# METROPOLITAN GOVERNMENT OF NASHVILLE AND DAVIDSON COUNTY

## STAFF RECOMMENDATION 2137 Ashwood Avenue July 17, 2019

**Application:** New Construction-Infill  
**District:** Hillsboro-West End Neighborhood Conservation Zoning Overlay  
**Council District:** 18  
**Base Zoning:** RS7.5  
**Map and Parcel Number:** 104 15 0 209.00  
**Applicant:** Martin Wieck, Nine 12 Architects  
**Project Lead:** Jenny Warren, jenny.warren@nashville.gov

**Description of Project:** Application for the construction of single-family infill.

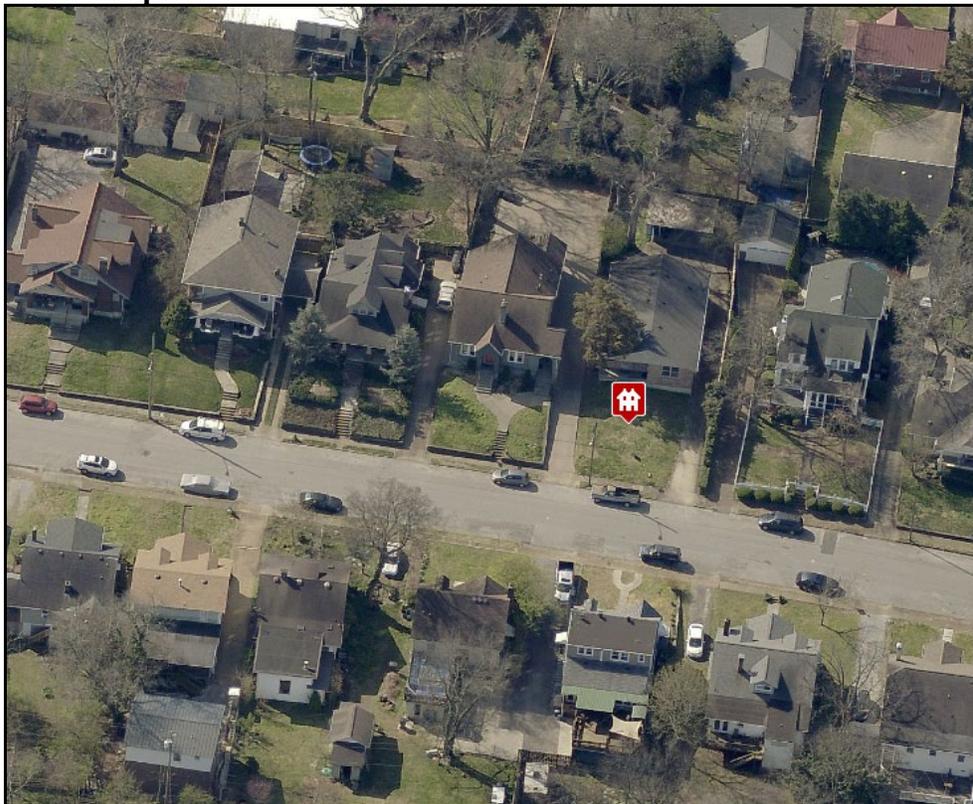
The proposed eaves are about sixteen feet (16') from finished floor. This eave height creates a second-story knee wall with shingled wall facing the street below the eave line. This is not a typical historic element. (Figure 4)

With the overall height of the proposed building being taller than the tallest building in the vicinity, the primary form having an eave height more akin to two-story buildings

than the one-and-a-half story buildings in the context, and the width being at the wider end of the historic context, staff finds that the scale of the house is too large. Staff recommends that ridge height be lowered at least one foot (1') and the eave height be lowered at least two feet (2'). The eave height will still be tall for the context, at approximately fourteen feet (14') but the result will be that the wall between the porch roof and the main roof form will read as all roofing from the front. With the reduction in height, the width may be appropriate.

1. The ridge height shall be lowered at least one foot (1');
2. The primary eave height shall be lowered at least two feet (2');
3. The front setback will be verified by MHZC staff in the field at staking;
4. The finished floor height shall be consistent with the finished floor heights of the adjacent historic houses, to be verified by MHZC staff in the field;
5. Staff approve the roofing color, porch posts, door selections, porch hood materials and walkway material; and
6. The HVAC shall be located behind the house or on either side, beyond the midpoint of the house, and utility meters shall be located on the side of the building, within five feet (5') of the front corner or on the rear or rear-side within five feet (5') of the rear corner. Alternative mechanical and utility locations must be approved prior to an administrative sign-off on building permit(s),

SITE PLAN  
 01

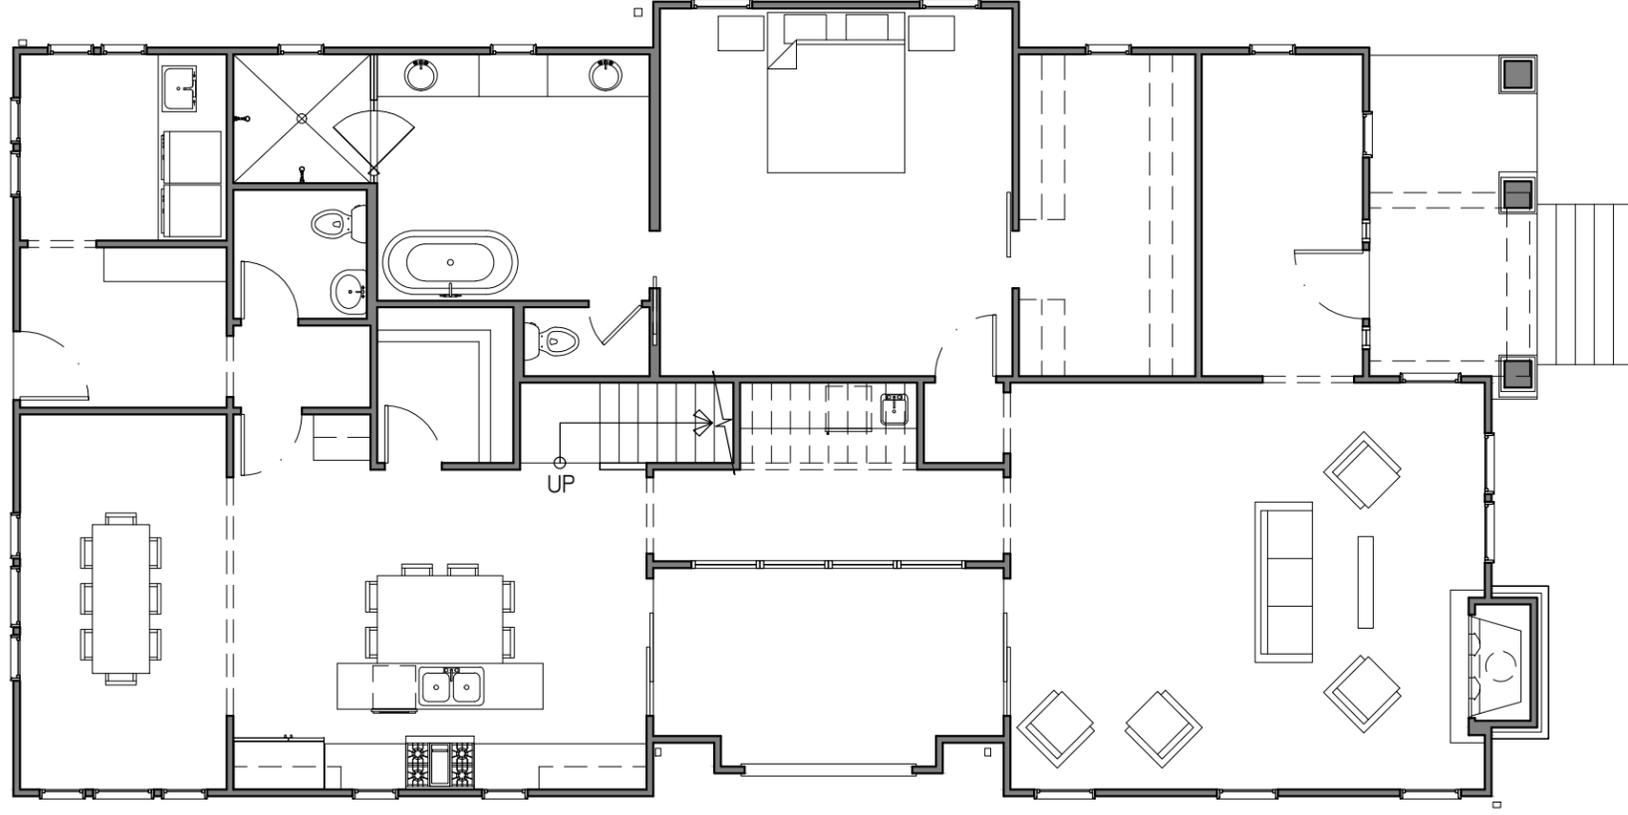
The front setback is indicated to be about thirty-seven feet (37'). The front wall of the house will align with the front wall of the four historic houses to the east (to the left in Figure 5). The historic house next door to the right is set back further on the lot than the other houses on the block. Staff finds that it is appropriate to align the front setback with the majority of the historic houses on the block. The left side setback is five feet (5'). On the right, the house will sit at least ten feet (10') from the property line. The rear of the house is approximately fifty feet (50') from the rear property line.

Outbuildings: No outbuilding is proposed at this time, though the future location of a detached accessory dwelling unit is indicated on the site plan. Given the base zoning, a second unit may not be possible on this lot.
